Final Environmental Statement

related to the operation of
Limerick Generating Station,
Units 1 and 2

Docket Nos. 50-352 and 50-353

NUREG-0974

Figure 5.4r Estimated latent cancer fatality risk, excluding thyroid (persons) from severe reactor accidents for nuclear power plants having plant-specific PRAs, showing estimated range of uncertainties. See footnotes at the end of Figure 5.4v.

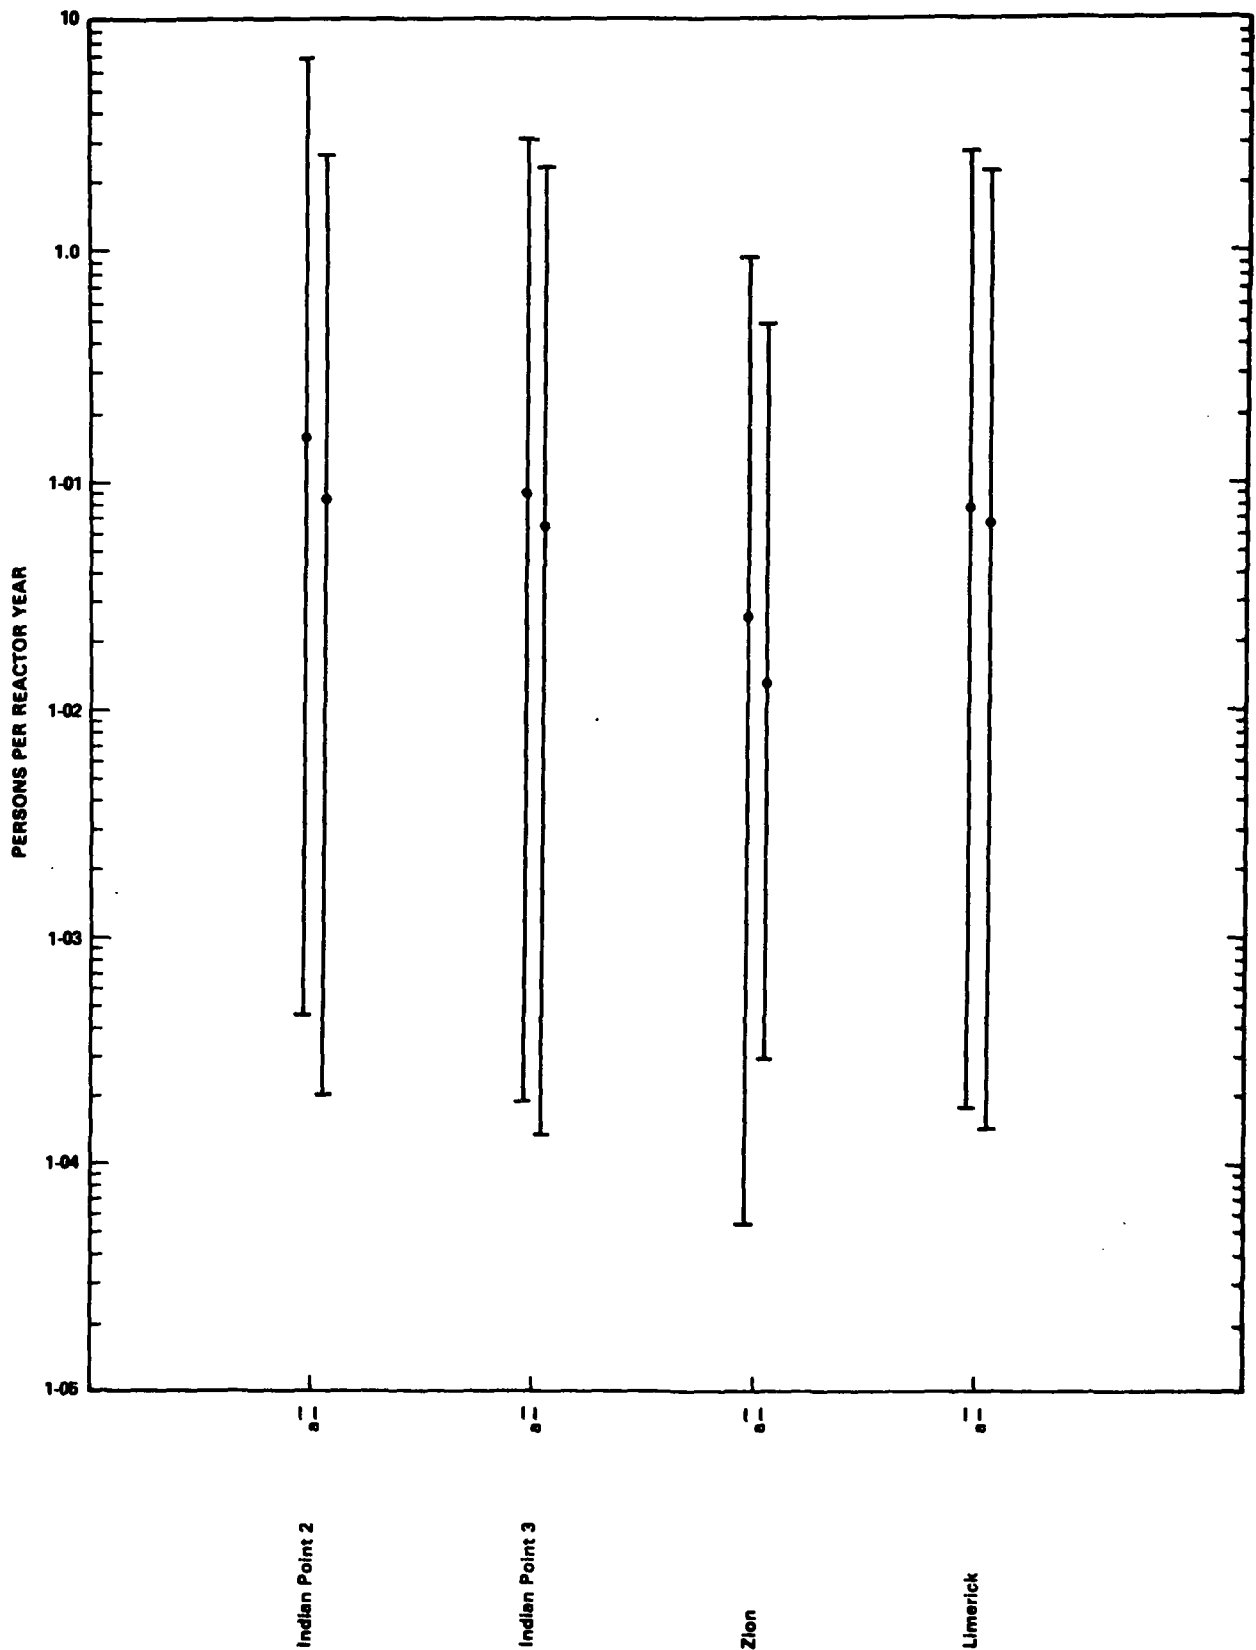
Figures 5.4n, o, p, q, r: The uncertainty bounds, contradict the text on page 5-54, which states that "the risk uncertainty bounds could be well over a factor of 10, but not as large as a factor of 100. Within these uncertainty bounds, however, the uncertainties associated with the probability-integrated values of consequences (the risks) are likely to be less. . .". No explanation is provided of what the uncertainty bounds represent. They appear to be an arbitrary factor of 100 in all cases. It is expected that the point estimate represents something greater than a 50% confidence level and may be greater than the 90% confidence level in some cases. It is believed that the weight of evidence supports a realistic estimate of risk considerably lower than the DES values and that the DES point estimates are much nearer the upper estimate than the median.

Figure 5.8 Sketch of relative positions of cooling towers, generator step-up transformers, and nearest residences at Limerick.

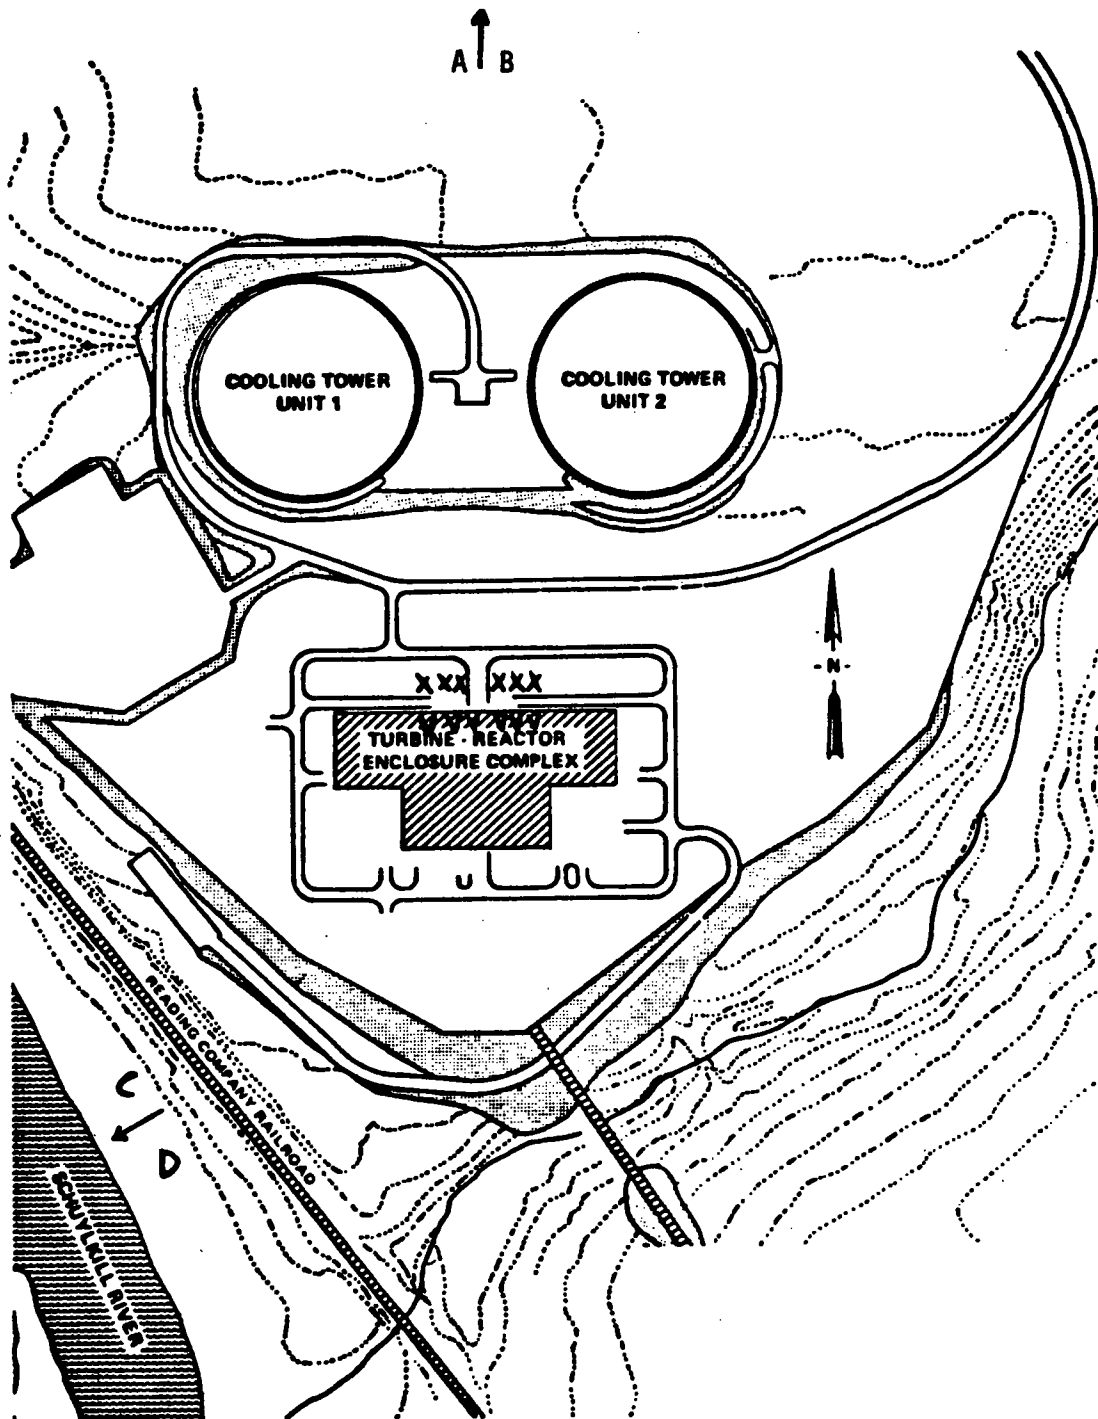
PECO comments that residences C and D on Figure 5.8 are inaccurately shown.

Figure 5.8: The location of residences C and D are inaccurately shown on this figure. There are no residences between the plant and the river. Refer to EROL Table 2.1-37.

Figure 5.8 has been changed to indicate that the locations of residences C and D are across the Schuylkill River from the LGS site, off the figure.
